Bid 21-52
Downtown Bike Path Rehabilitation
Bid opening: August 2, 2021

ADDENDUM NO. 1
Page 1 of 9

FROM: Engineering Division, City of Aurora

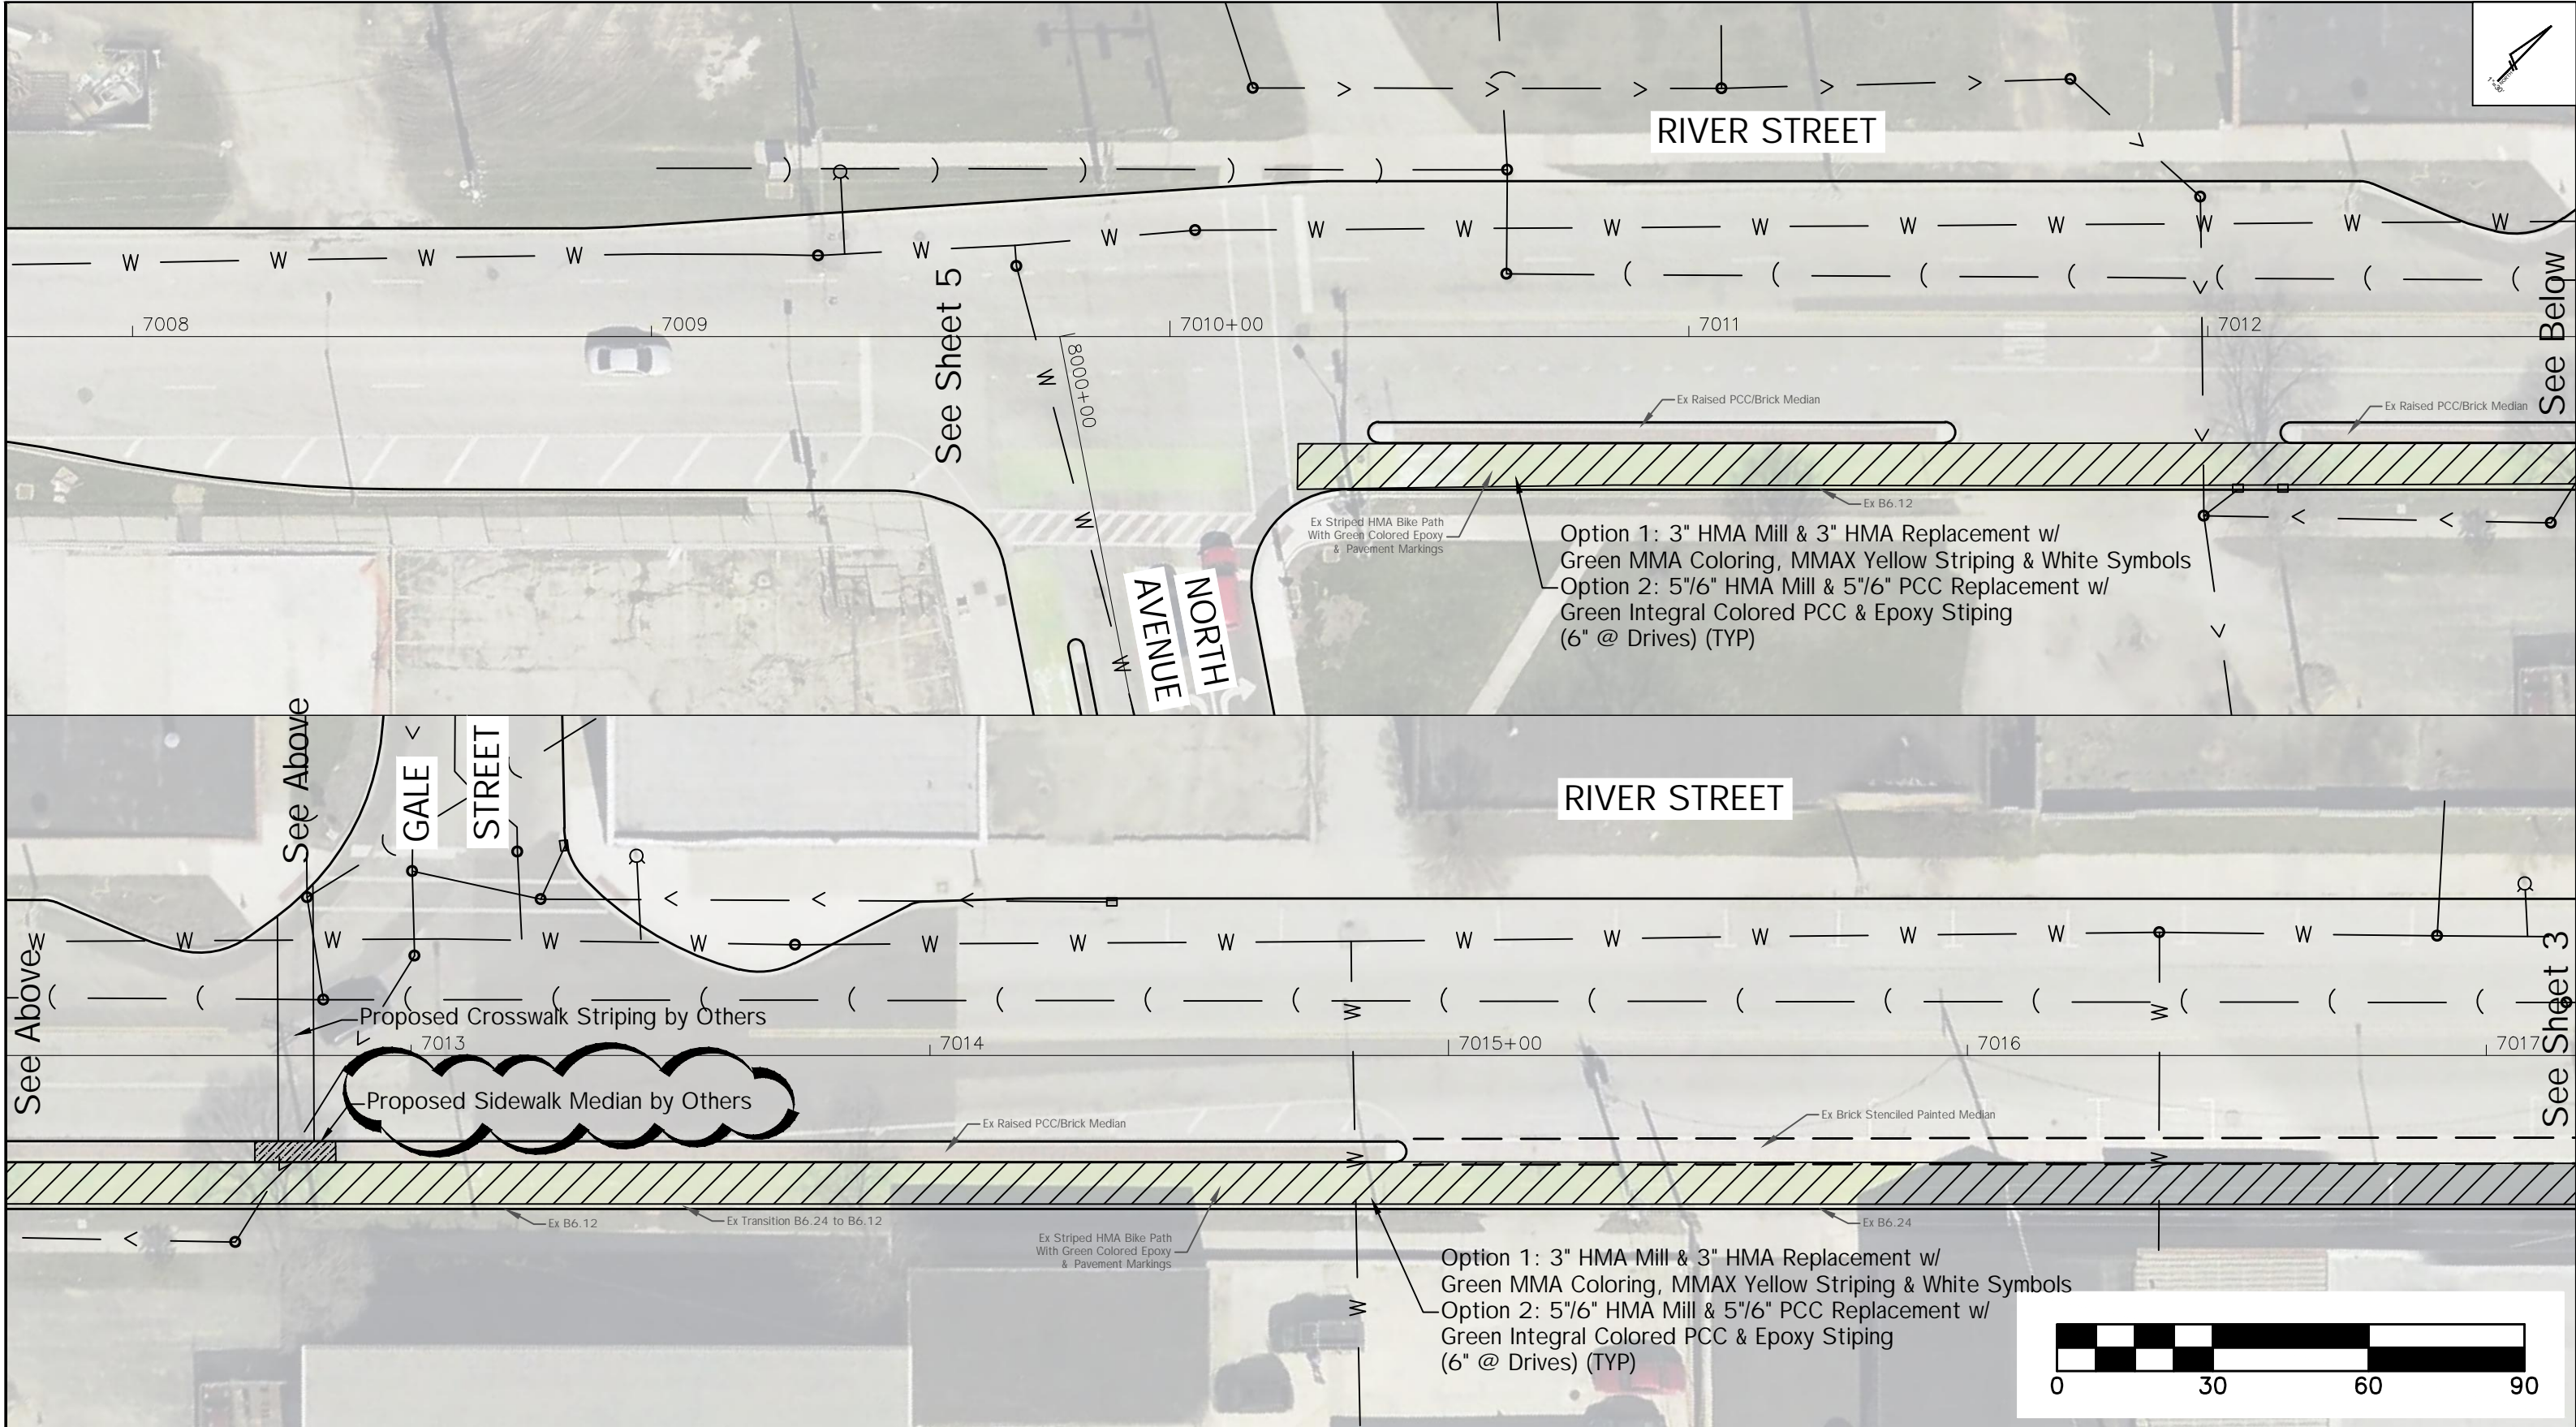
1. The pay item for Hot-Mix Asphalt Surface Course, Mix "D", N50 has been added to the bid schedule in both Options for the 3" HMA replacement.
2. The median removal and replacement at Gale Street have been eliminated and will be done by Others. The plan set has been updated to show it being done by Others. Also pay items were eliminated for Median Removal; PCC Median, 6"; PCC Sidewalk, 6". The Brick Removal and Replacement pay item area has been reduced.

3. A new plan set has been provided which now includes an aerial overlay. Notes were added for the median removal and replacement by others at Gale Street and the existing concrete driveways to remain and be colored with MMA and striped with MMAX.

CITY OF AURORA ENGINEERING DIVISION 77 SOUTH BROADWAY	REVISIONS: 1. Addendum No. 1 7/26/2021 - Median & Adding Aerial			PROJECT Downtown Bike Path Rehabilitation SHEET TITLE RIVER STREET - STA 7008+00 TO 7017+00	SHEET NUMBER 2 TOTAL SHEETS 5
		DESIGNED BY: JDH	CHECKED BY: JDH	SCALE: 1" = 30'		
		DRAWN BY: JJ	APPROVED BY: JDH	DATE: 1/2020

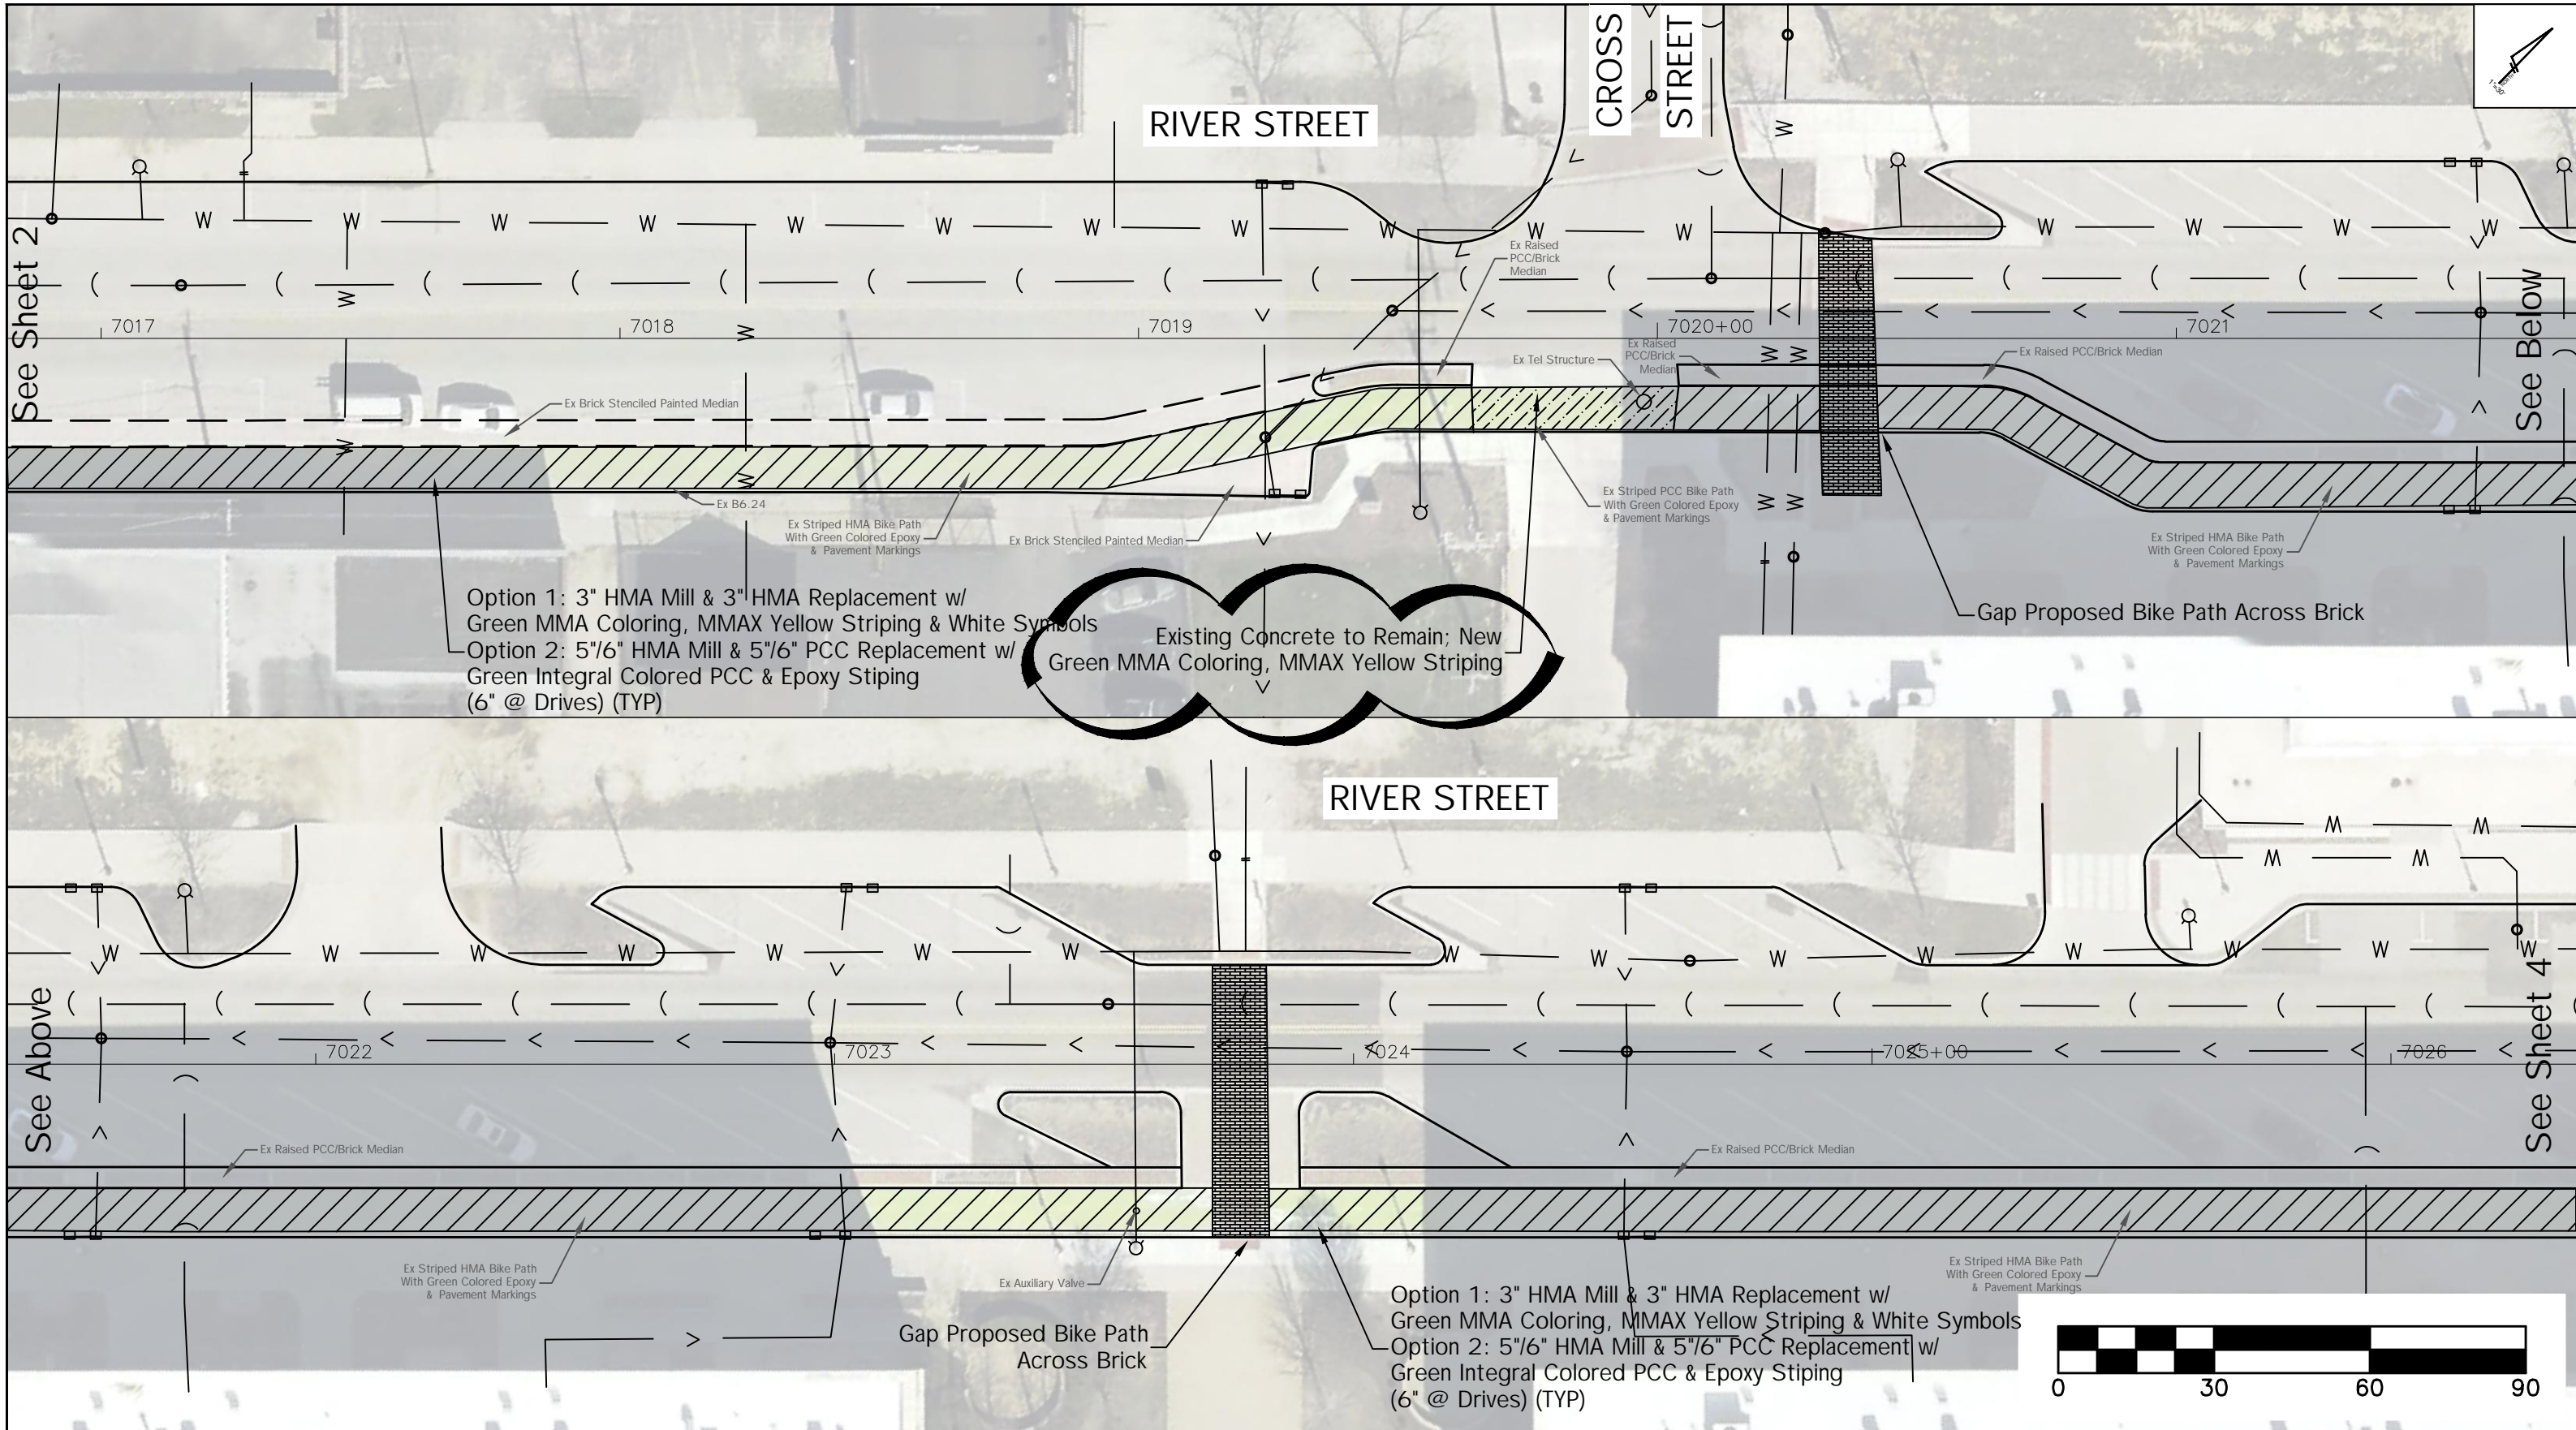
CITY OF AURORA ENGINEERING DIVISION 77 SOUTH BROADWAY	REVISIONS: 1. Addendum No. 1 7/26/2021 - Added Aerial & Existing PCC Driveway Callout			PROJECT Downtown Bike Path Rehabilitation	SHEET NUMBER 3
		DESIGNED BY: JDH	CHECKED BY: JDH	SCALE: 1" = 30'	SHEET TITLE RIVER STREET - STA 7017+00 TO 7026+00	TOTAL SHEETS 5
		DRAWN BY: JJ	APPROVED BY: JDH	DATE: 1/2020

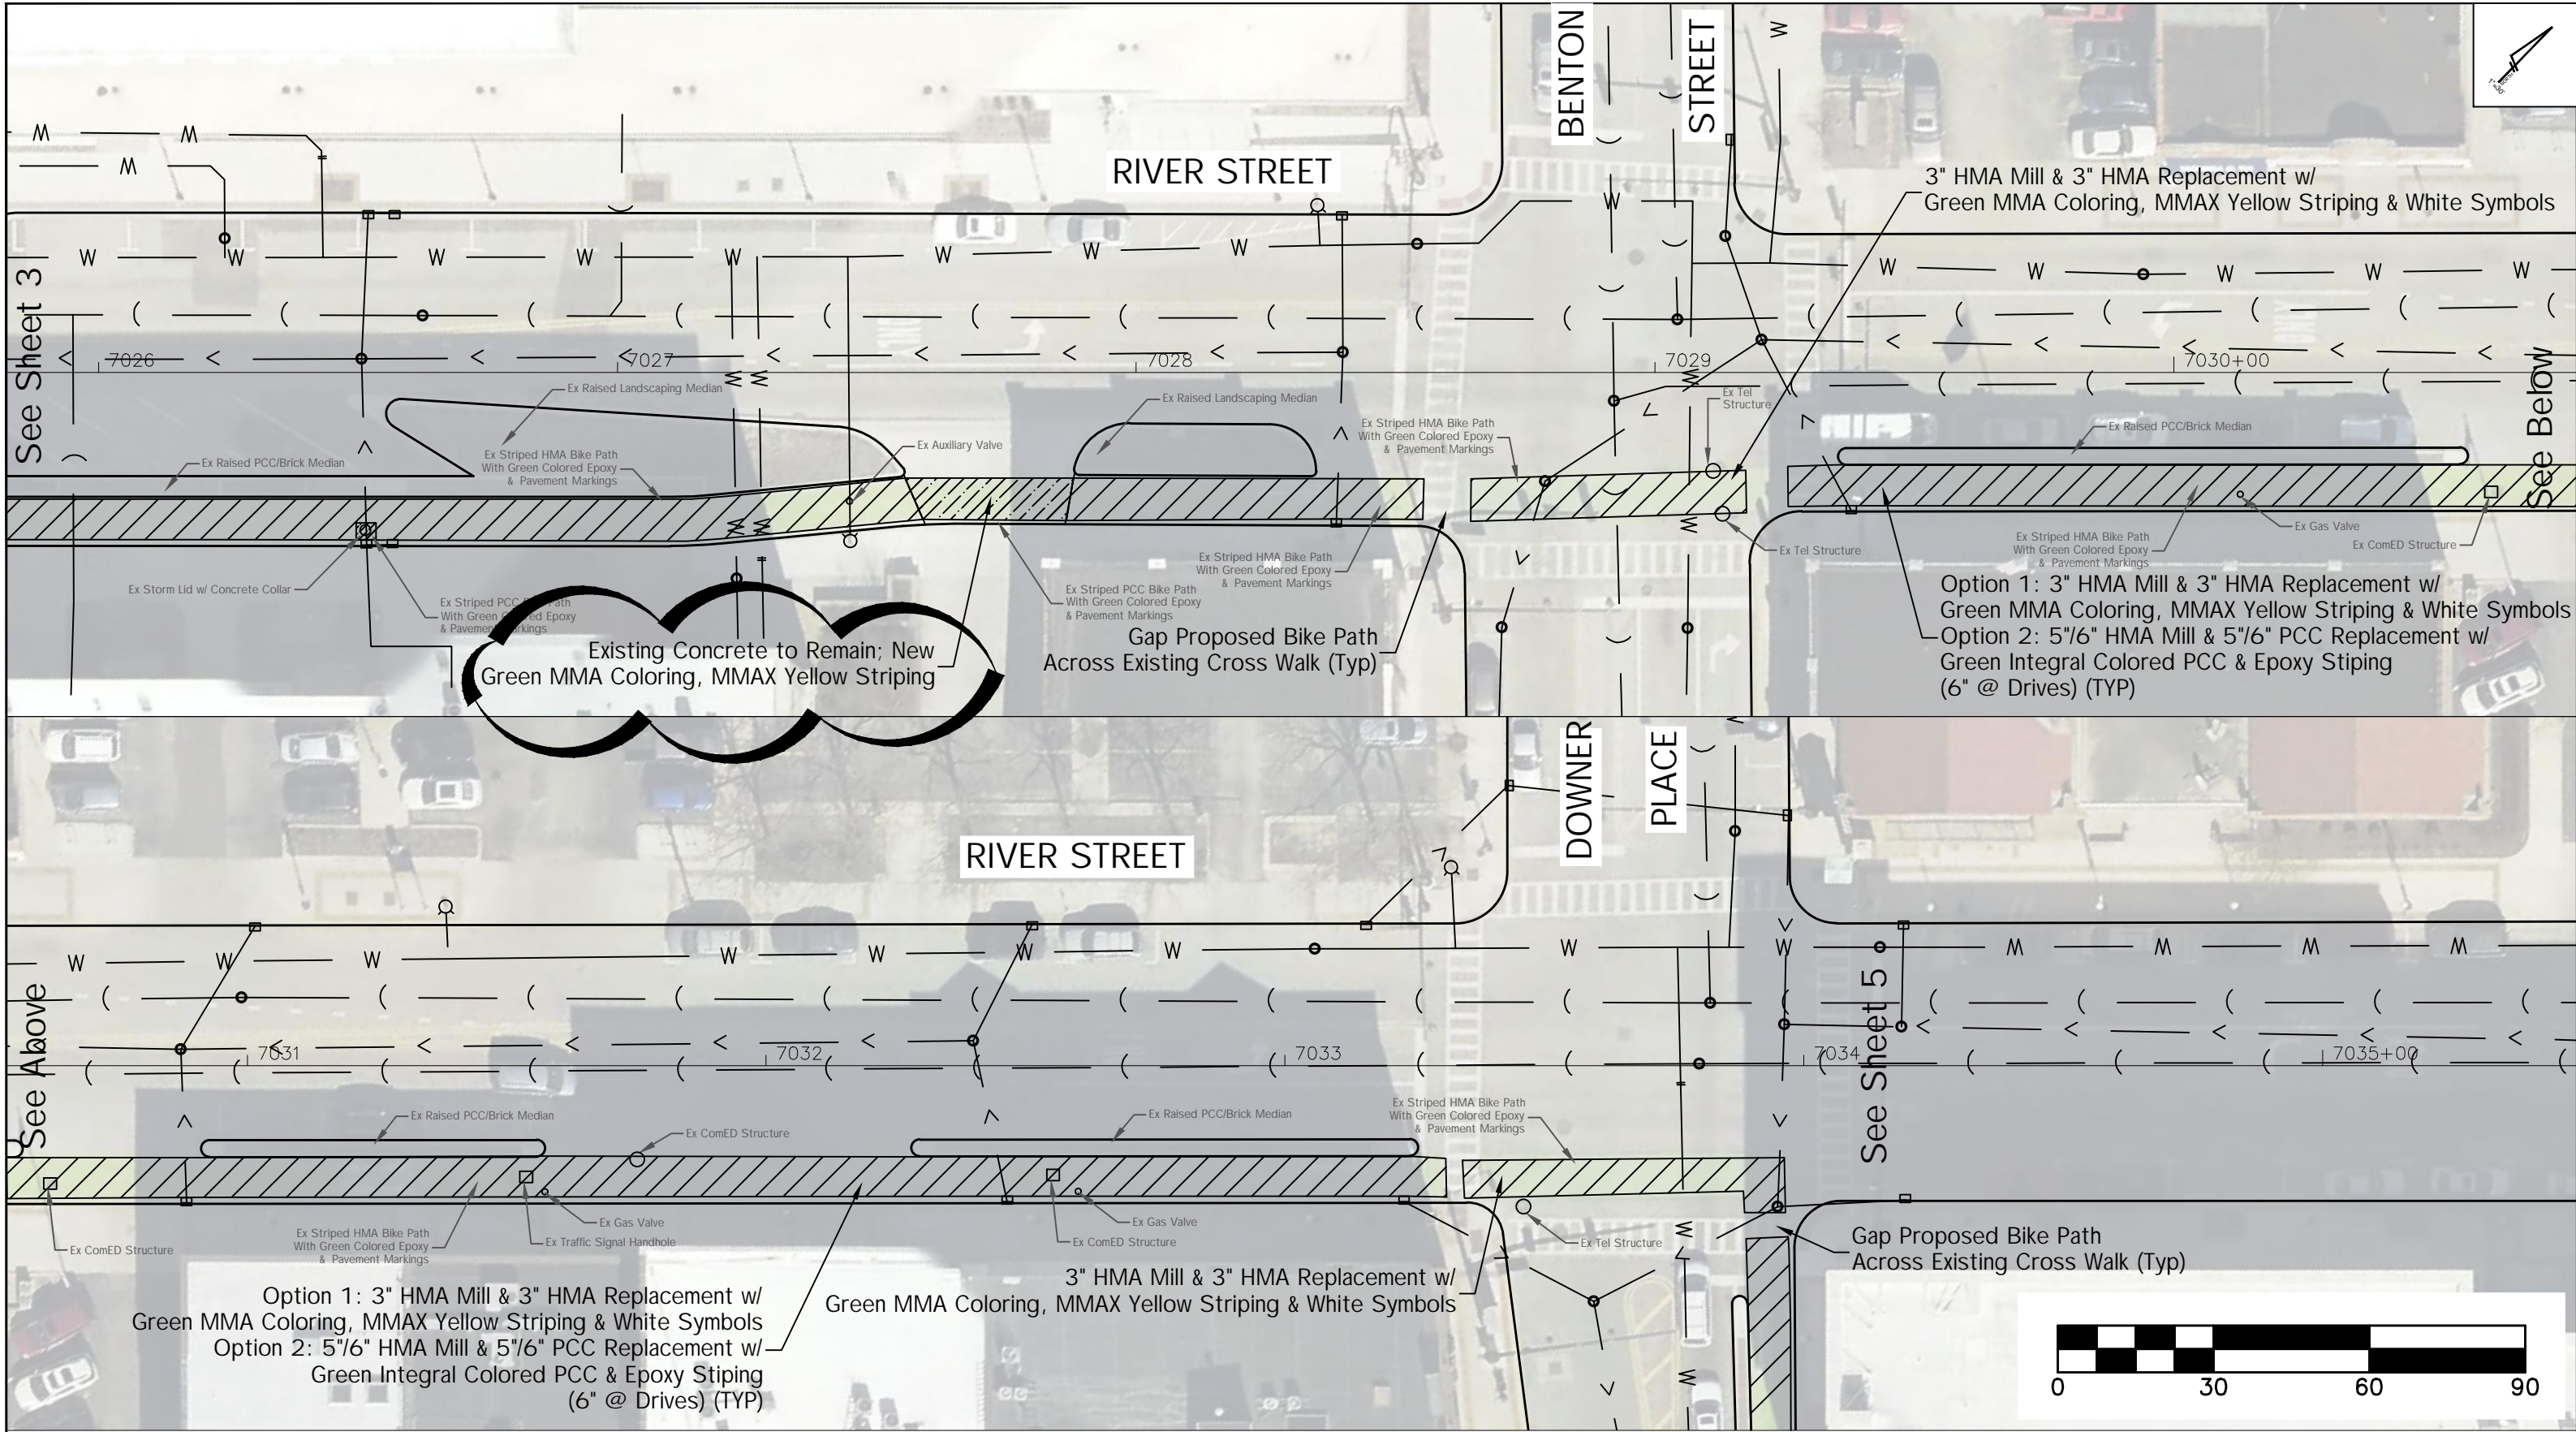
CITY OF AURORA ENGINEERING DIVISION 77 SOUTH BROADWAY	REVISIONS: 1. Addendum No. 1 7/26/2021 - Added Aerial & Existing PCC Driveway Callout			PROJECT Downtown Bike Path Rehabilitation SHEET TITLE RIVER STREET - STA 7026+00 TO 7035+00	SHEET NUMBER 4 TOTAL SHEETS 5
		DESIGNED BY: JDH	CHECKED BY: JDH	SCALE: 1" = 30'		
		DRAWN BY: JJ	APPROVED BY: JDH	DATE: 1/2020
